Disposition of Cesium-137 Contaminated Emission Control Dust and Other Incident-Related Material; Final Staff Technical Position

ACTION: Notice: final staff technical position.

Analysis of and Response to Comments on Staff Technical Position "Disposition of Cesium-137 Contaminated Emission Control Dust and Other Incident-Related Material"

Figure 1. Shape Factor Plot for 20 Cubic Yard Container

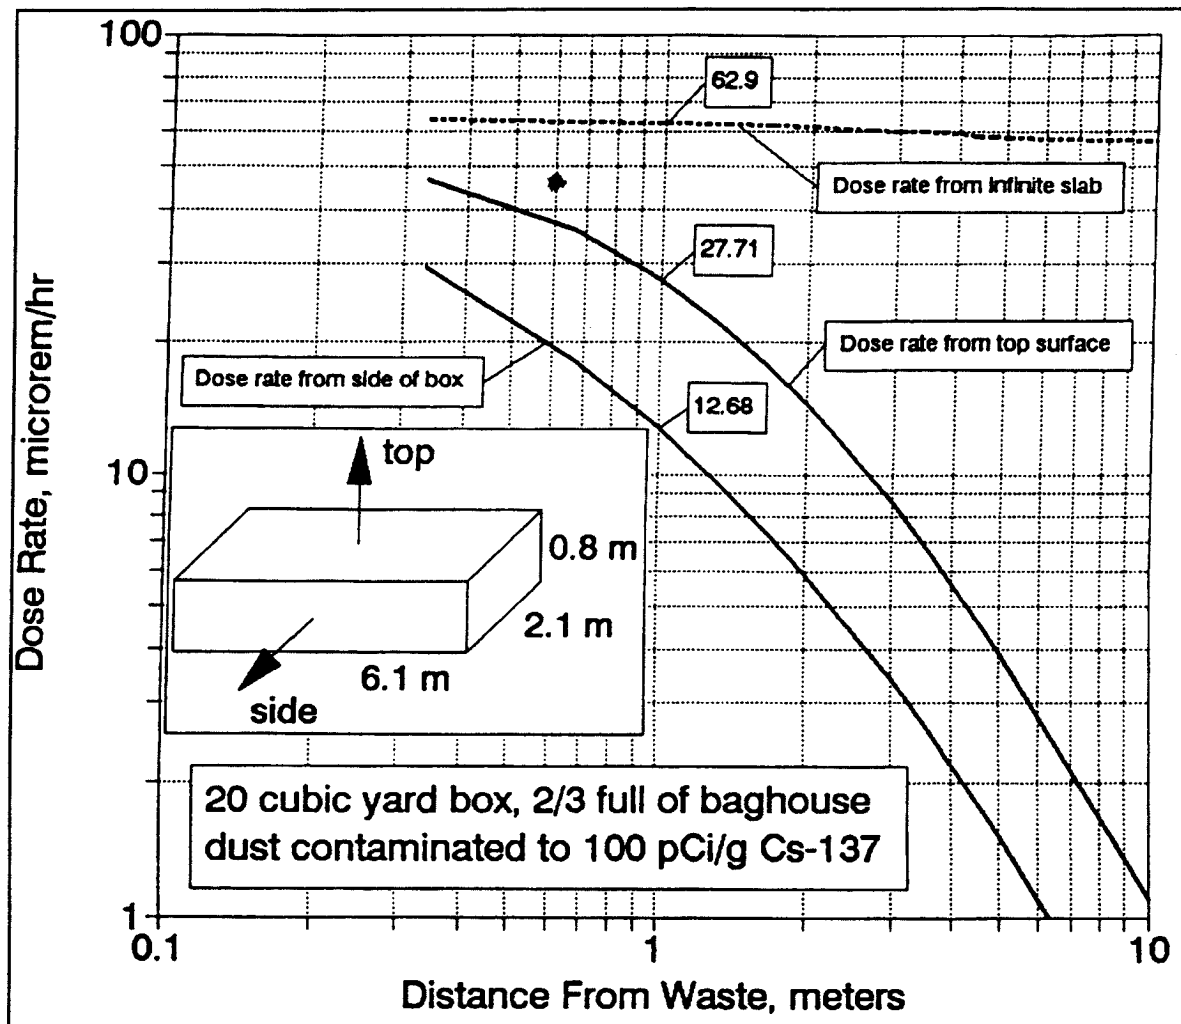
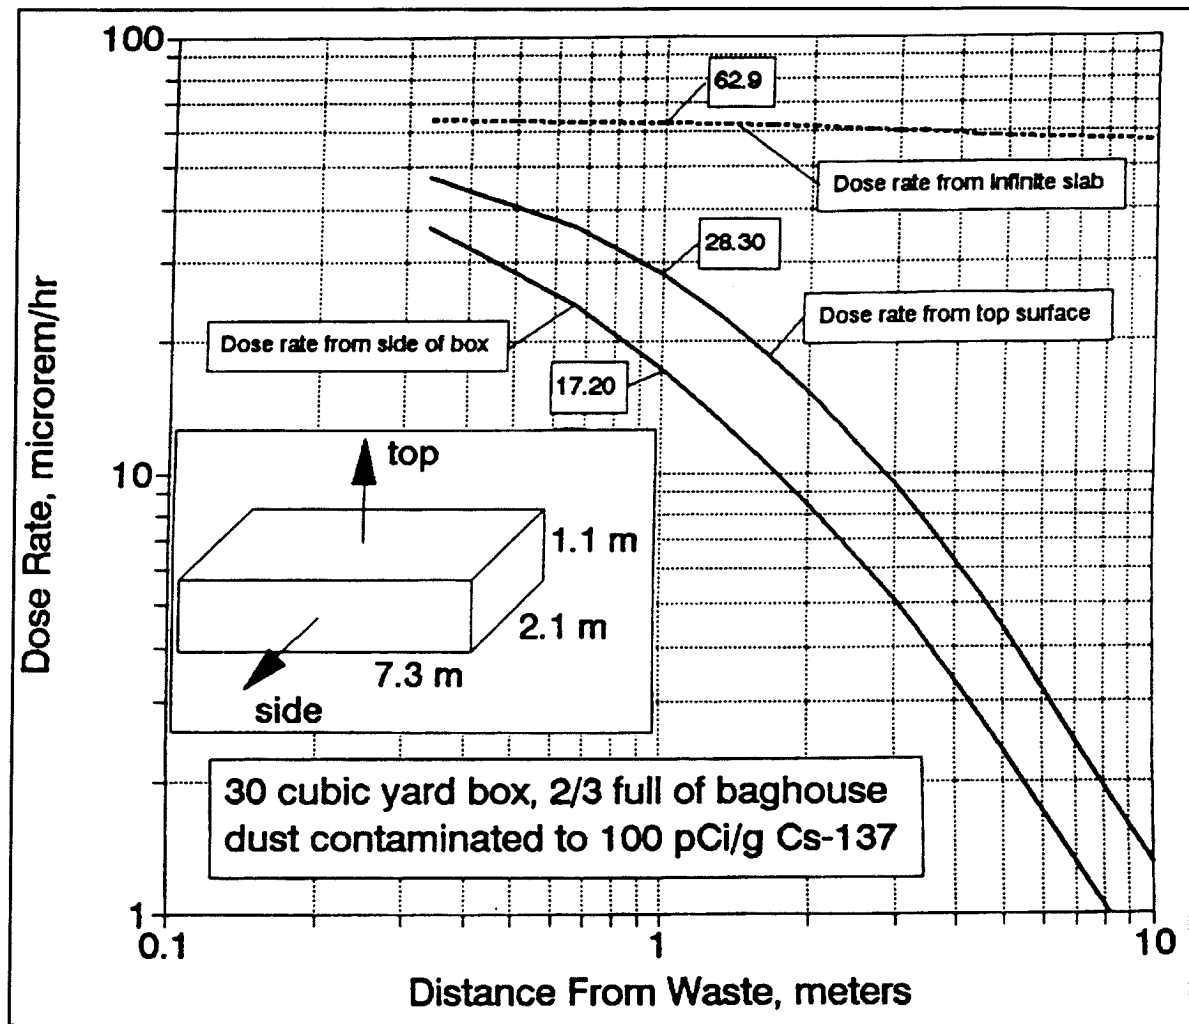
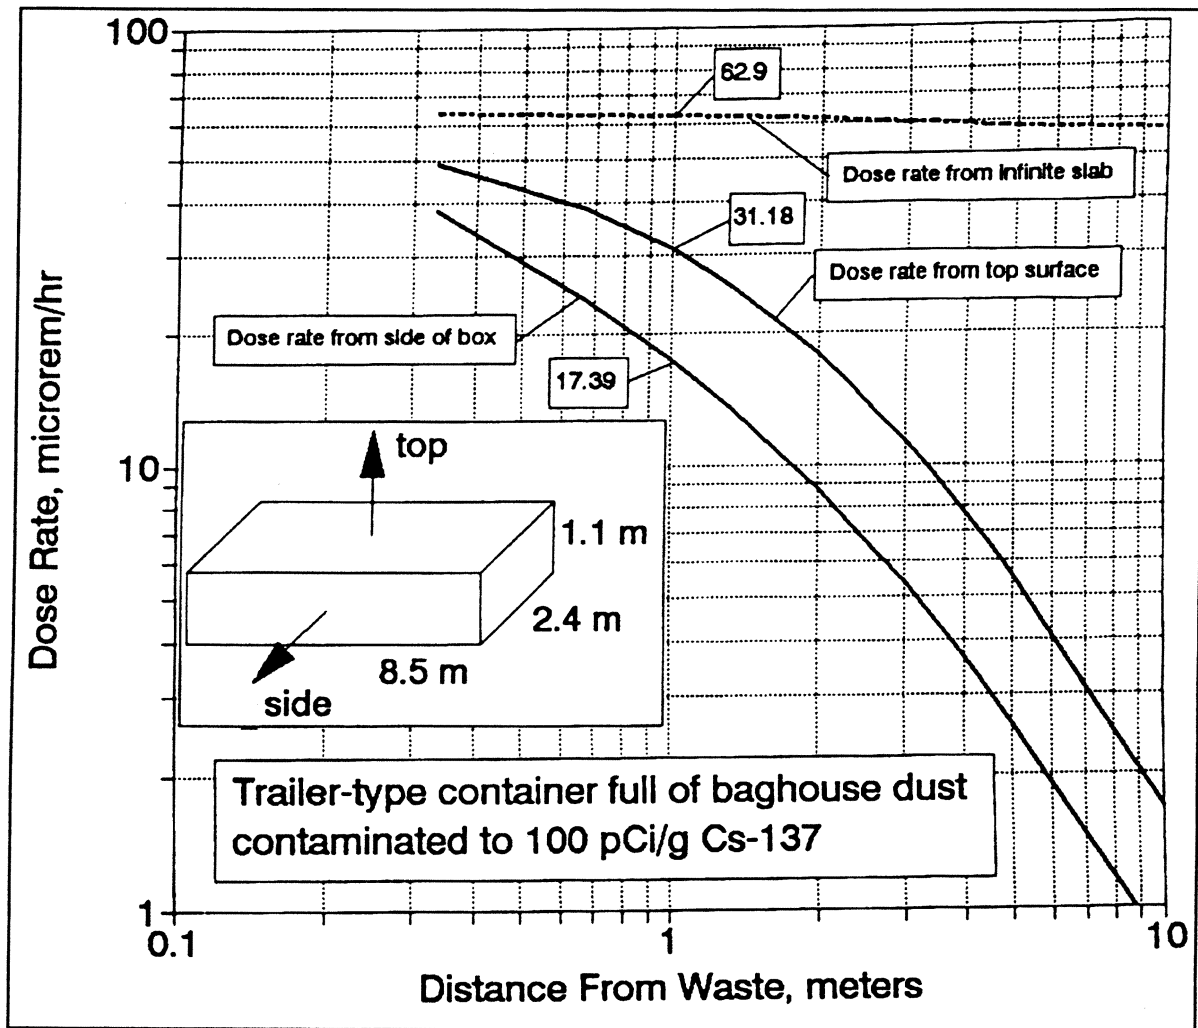
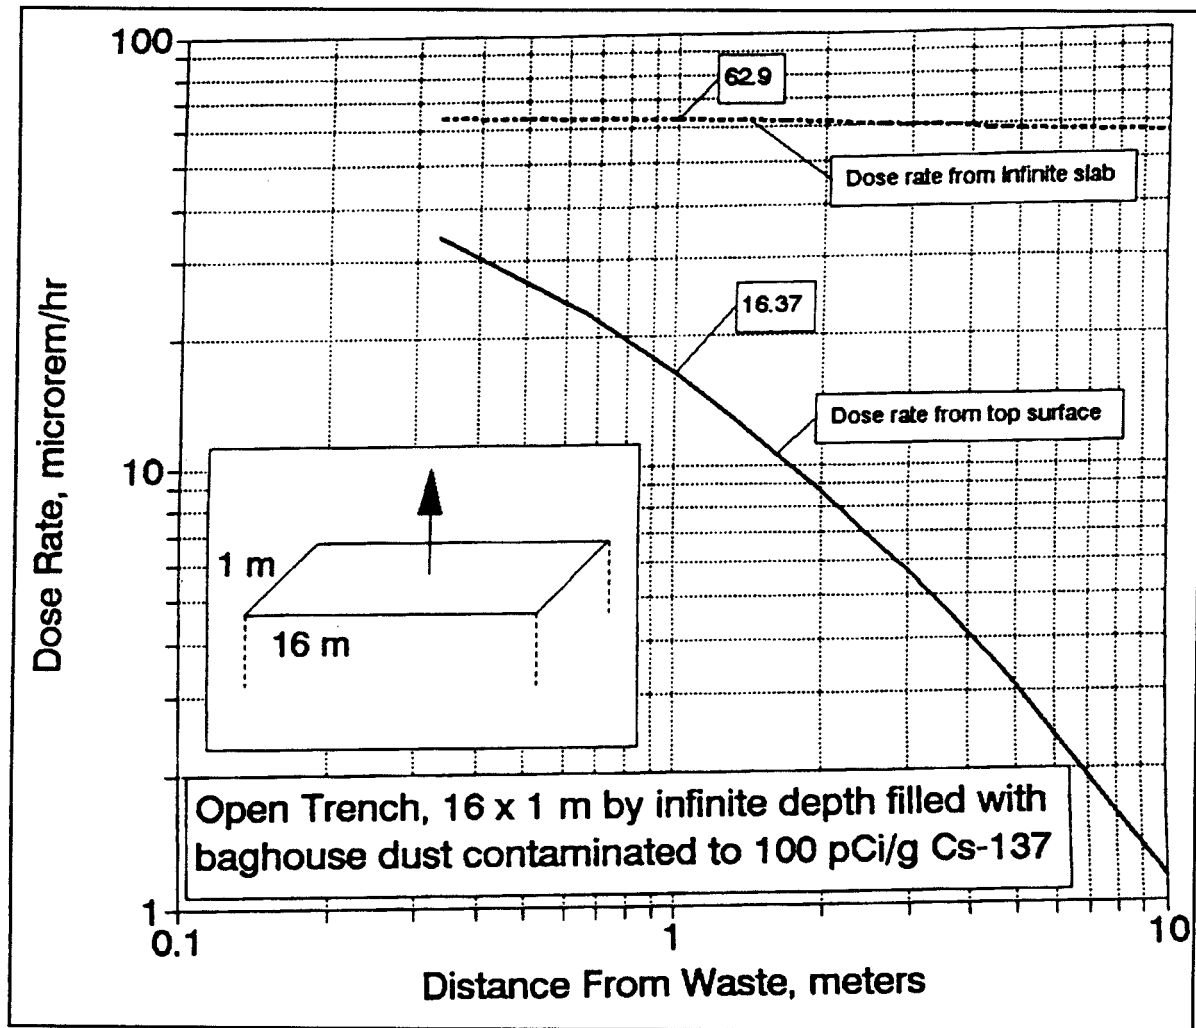
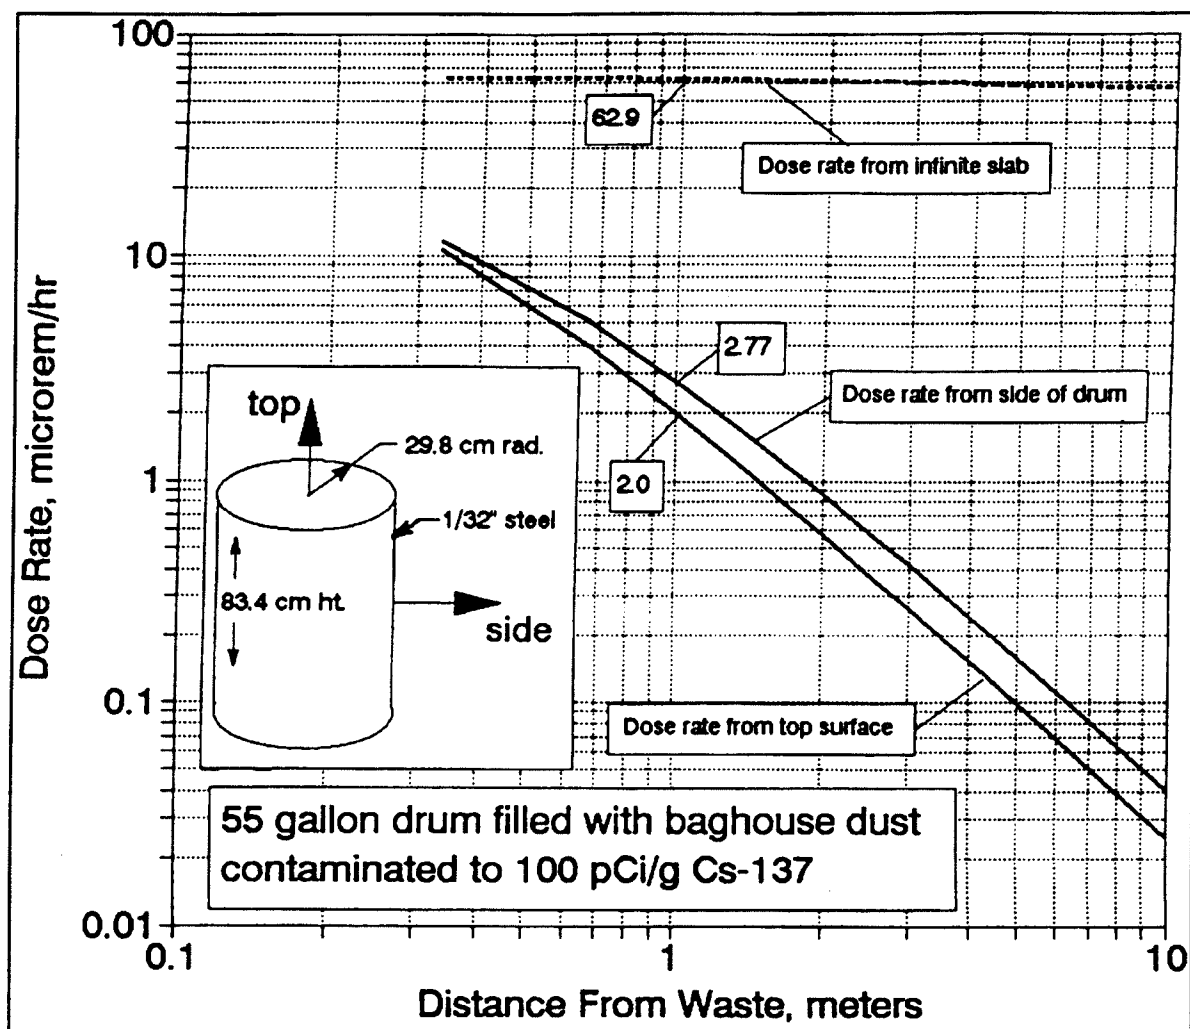
d. *Comment:* An industrial association commenter suggested that the area/shape factors used by NRC were overly restrictive by a factor of 2.

d. *Response:* NRC became aware of area/shape factor differences between different codes. Staff has checked its calculations and does not believe its estimates are in error.

f. *Comment:* An industrial association commenter questioned the accuracy of the

f. *Response:* The publication of the figures in the **Federal Register** caused some blurring that has caused the commenter to misread the indicated dose rate. Comparisons with the scale on the ordinate indicate that the commenter's figure is high by a factor of 10.
